State of New Mexico
Energy, Minerals and Natural Resources

SUNDRY NOTICES AND REPORTS ON WELLS (DO NOT USE THIS FORM FOR PROPOSALS TO DRILL OR TO DEEPEN OR PLUG BACK TO A DIFFERENT RESERVOIR. USE "APPLICATION FOR PERMIT" (FORM C-101) FOR SUCH PROPOSALS.)	
1. Type of Well: Oil Well <input checked="" type="checkbox"/> Gas Well <input type="checkbox"/> Other <input type="checkbox"/> NM OIL CONSERVATION ARTESIA DISTRICT	
2. Name of Operator Devon Energy Production Company, LP	OCT 17 2018
3. Address of Operator 333 W. Sheridan Avenue, Oklahoma City, OK 73102	RECEIVED
4. Well Location Unit Letter ___ O: 1980 feet from the ___ South ___ line and ___ 330 ___ feet from the ___ East ___ line Section 16 Township 23S Range 29E NMPM Eddy County, NM	
11. Elevation (Show whether DR, RKB, RT, GR, etc.) 2971' KB

Well Name: SPUD 16 ST 2			Field: Potato Basin		
Location:	1980 FSL	330 FEL	SEC 16-T23S-R29E	County: Eddy	State: New Mexico
Elevation:	2971' GL			Spud Date: 2/20/2005	Compl Date: 4/19/2005
API#:	30-015-33924	Prepared by:	Max Lubitz	Date: 9/27/18	Rev:

CONDITIONS FOR PLUGGING AND ABANDONMENT

PROPOSED WELLBORE

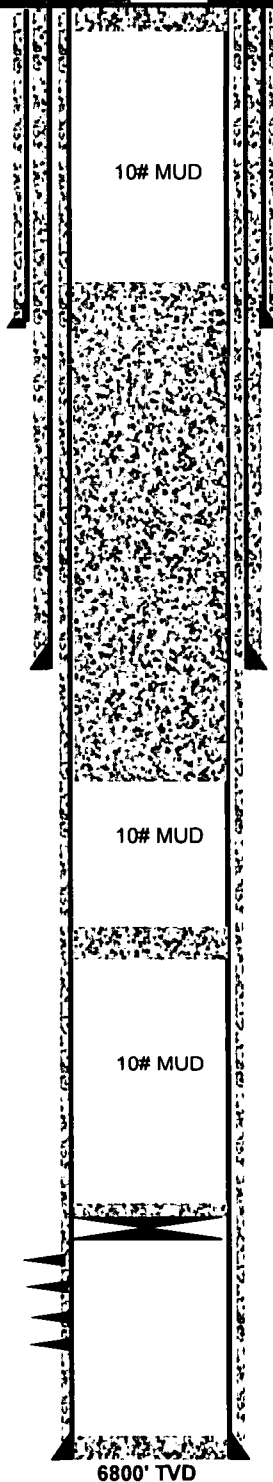
Notify OCD 24 hrs. prior to any work done.

R-111-1P
Area

- 25 1. MIRU P&A Unit.
2. Circulate 10# MLF. TOH 2-7/8" tubing.
3. Spot 20 sx CI C 3500-3600.
4. Spot 700 sx CI C 292-3000. WOC and Tag. (Shoe 2942, T Bell Canyon 2996', B Salt 2740 T Salt 378, R-111P.)
25 5. Spot 10 sx CI C 3'-33' 100'
6. Cut WH off 3' BGL, Set dry hole marker.

Proposed:
 1. Spot 10 sx CI C 3'-33'.
 2. Cut WH off 3' BGL, Set dry hole marker.

Proposed:
 Spot 700 sx CI C 292-3000. WOC and Tag.
 Shoe 2942, T Bell Canyon 2996', B Salt 2740 T
 Salt 378, R-111P.

Proposed:
 Circulate 10# MLF. Spot 20 sx CI C 3500-3600.
